**RESOLUTION No. 13/14-5
CITY OF DAYTON, OREGON**

Title: A Resolution Adopting Public Works Design Standards Update No. 6

TO: All Holders of Public Works Design Standards (PWDS) for the City of Dayton

SUBJECT: Public Works Design Standards Update No. 6 (DRAFT)

LAST REVISION DATE: SEPT 2013	JO # STANDARD
GATE VALVE AND VALVE BOX DETAIL	
(NTS)	
DAYTON, OR	DETAIL NO. 501

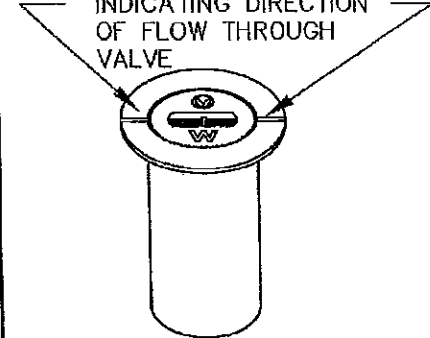
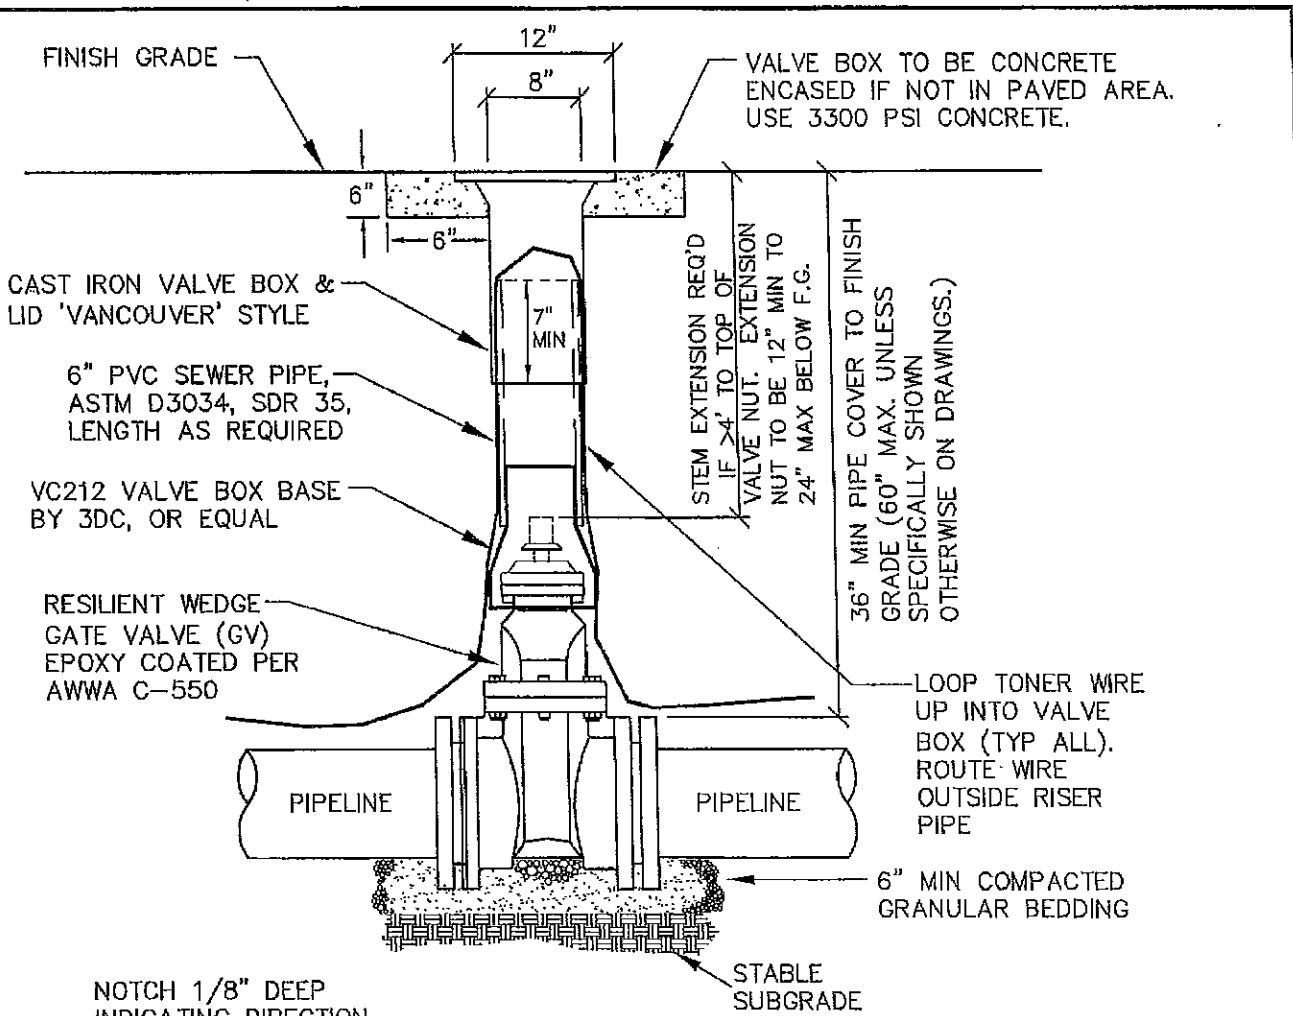
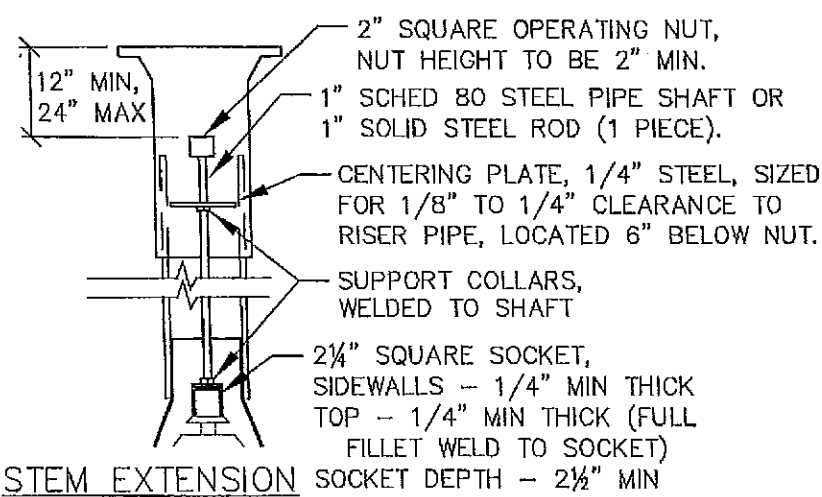
43. Details 501, 502, 503, 505, 506, 507, 517: The detail callouts were modified to clarify the designation of the standard valve box (910 style). The revised details (see attached) is dated 9/13.

LAST REVISION DATE: SEPT 2013	COPYRIGHT 1999 RES TECH ENGINEERING, INC.
STRADDLE BLOCK FOR 12" AND SMALLER PIPE	
(NTS)	
DAYTON, OR	DETAIL NO. 511

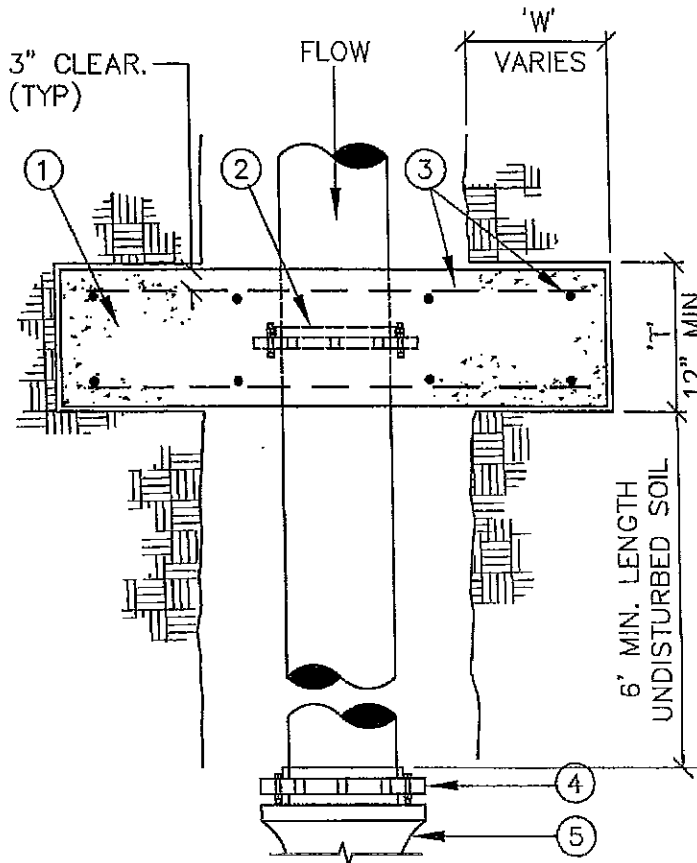
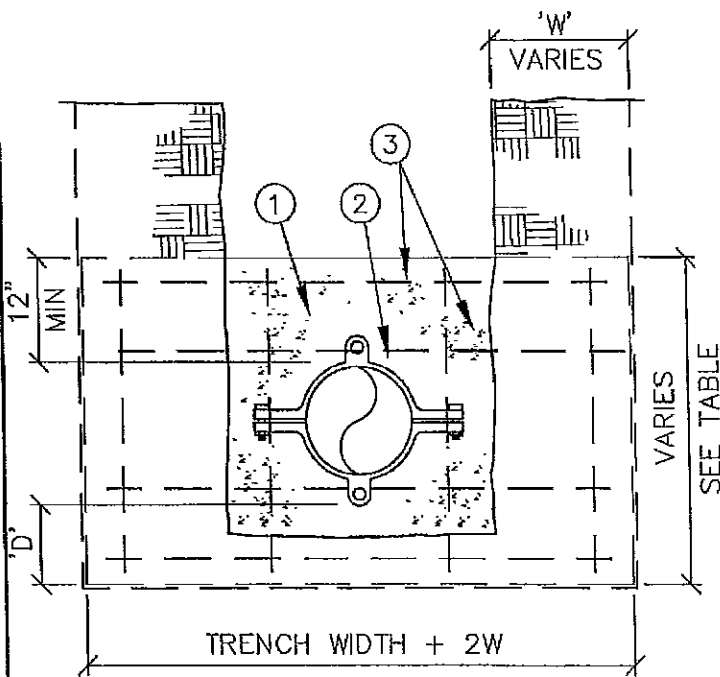
44. Detail 511: Modified to reflect standard straddle block for pipe size up to 12-inch diameter. Retainer fitting callout modified to reflect actual fitting currently available. The revised detail (see attached) is dated 9/13.

LAST REVISION DATE: NOV 2013	COPYRIGHT 1999 VESTECH ENGINEERING, INC.
TYPICAL 1" WATER SERVICE	
(NTS)	
DAYTON, OR	DETAIL NO. 515

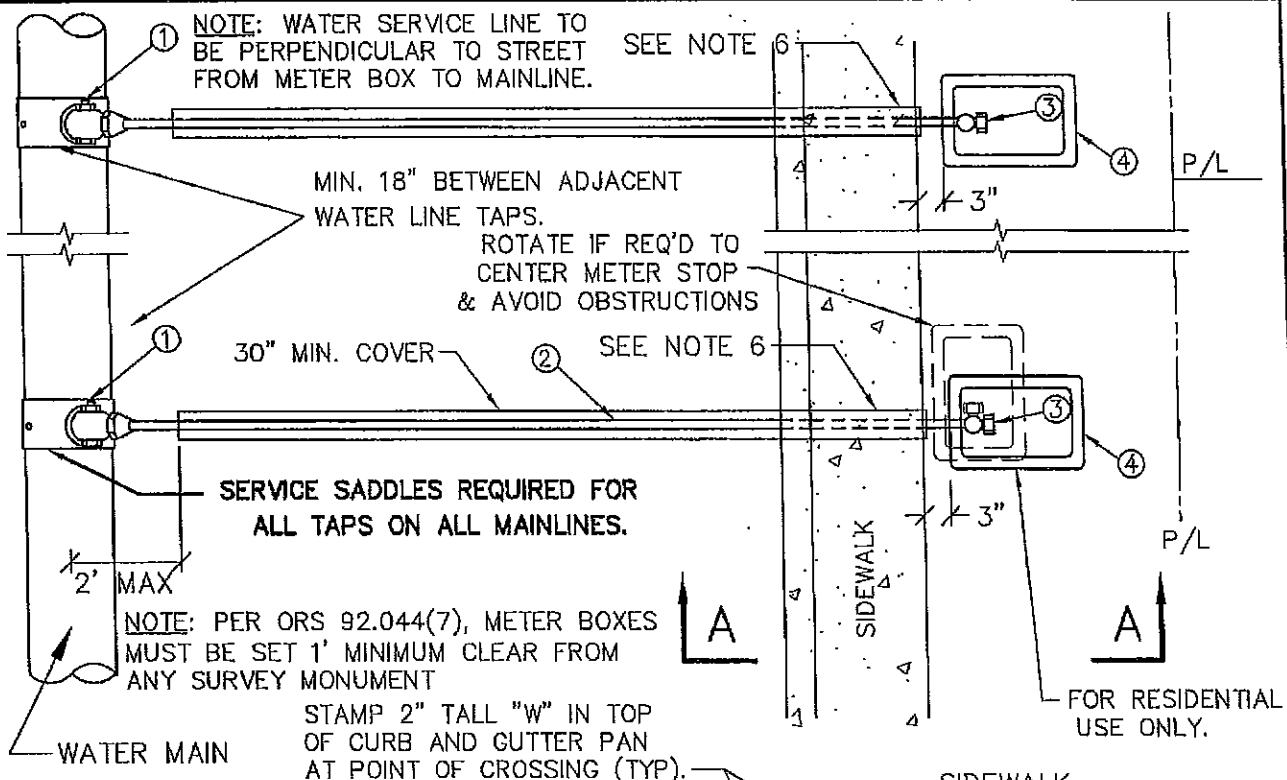
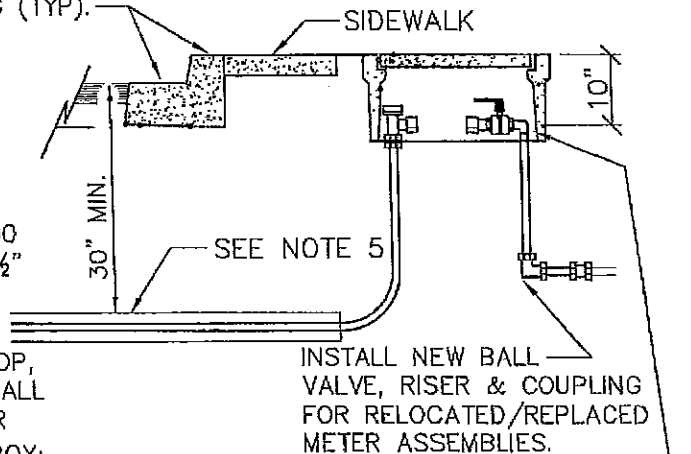
45. Details 515, 516 & 517. Modified to reflect new water service pipe used by Public Works. The revised details (see attached) are dated 11/13.
46. Detail 518: The detail callouts were modified to clarify several issues regarding installation configuration. The revised detail (see attached) is dated August 2013.

LAST REVISION DATE: JULY 2013	JD #
3" REDUCED PRESSURE ASSEMBLY	
(NTS)	
DAYTON, OR	DETAIL NO. 543

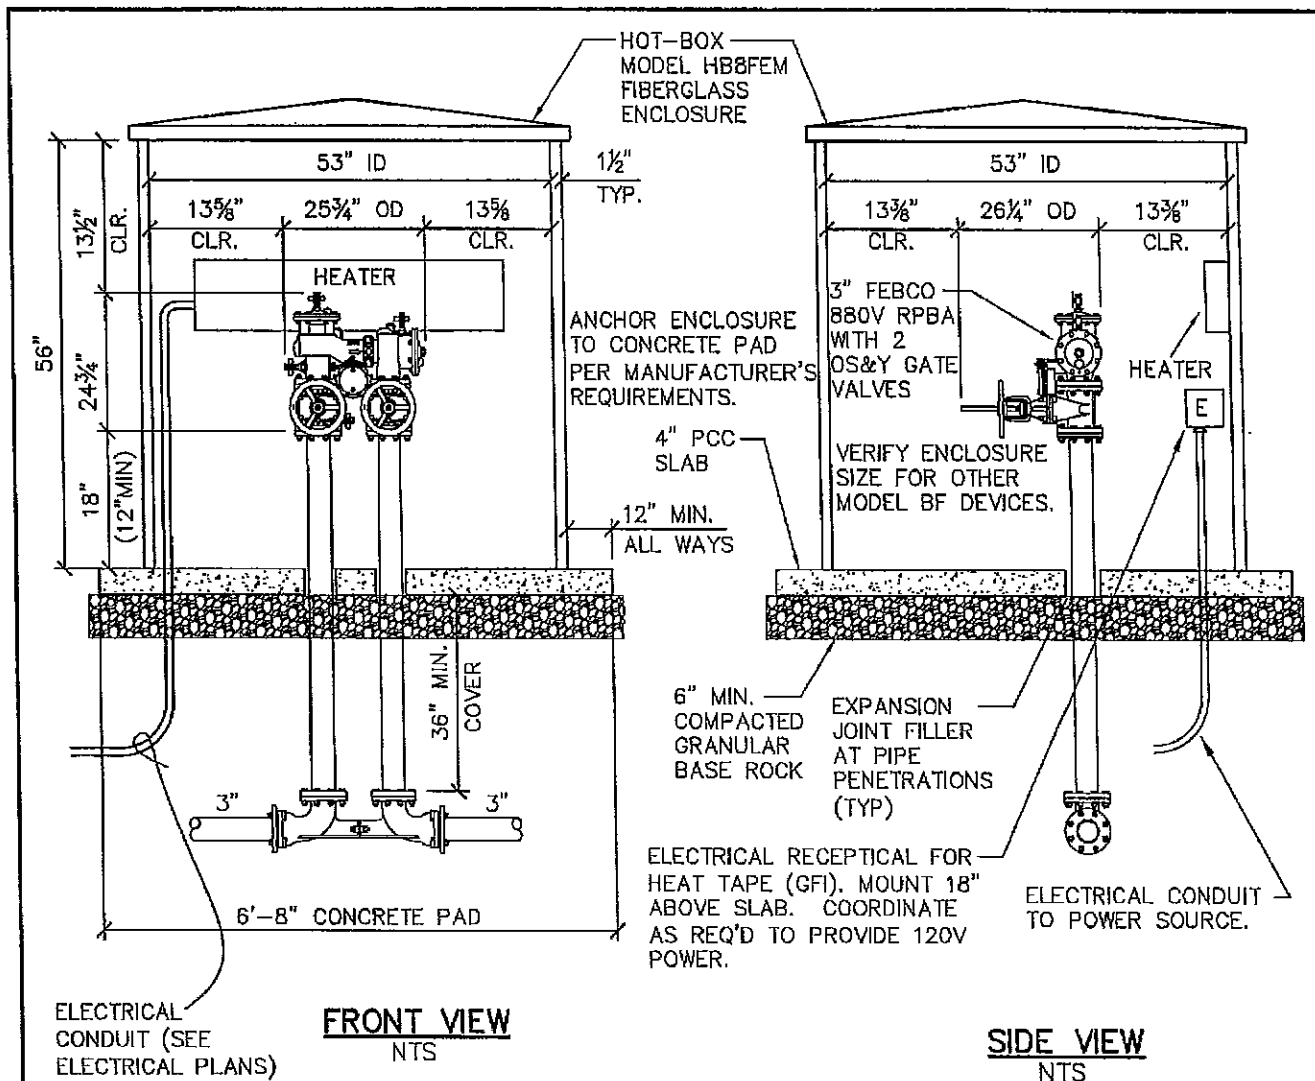
47. Detail 543: A new detail was added for a 3-inch reduced pressure backflow assembly (to complement the existing details for 2" and 4" assemblies). The new detail (see attached) is dated 7/13.

LAST REVISION DATE:	JO #
OCT 2013	STANDARD
BELOW GRADE CHECK VALVE & BALL DRIP VALVE, IN CLOSE BOTTOM DRAIN STRUCT (NTS)	
DAYTON, OR	DETAIL NO. 560

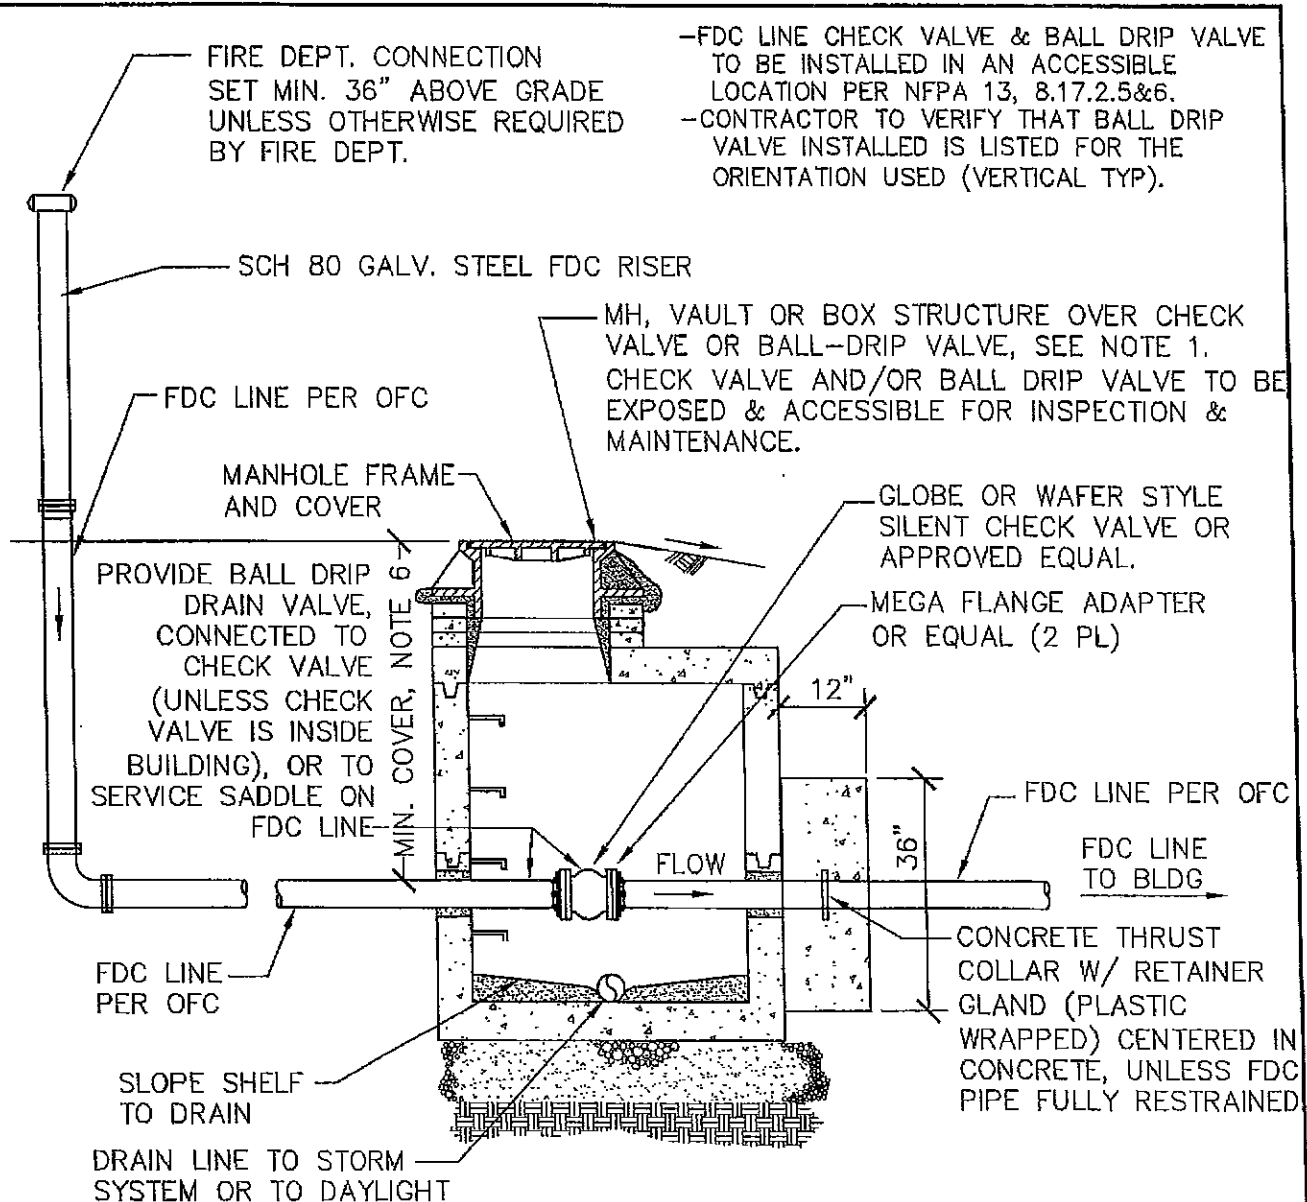
48. Detail 560, 561 & 562: New details were added to show a typical configuration of a check valve or drain valve on an FDC line when the backflow device is located inside the building, and the FDC riser is required by the Fire Chief to be located away from the building. The new details (see attached) are dated 10/13.
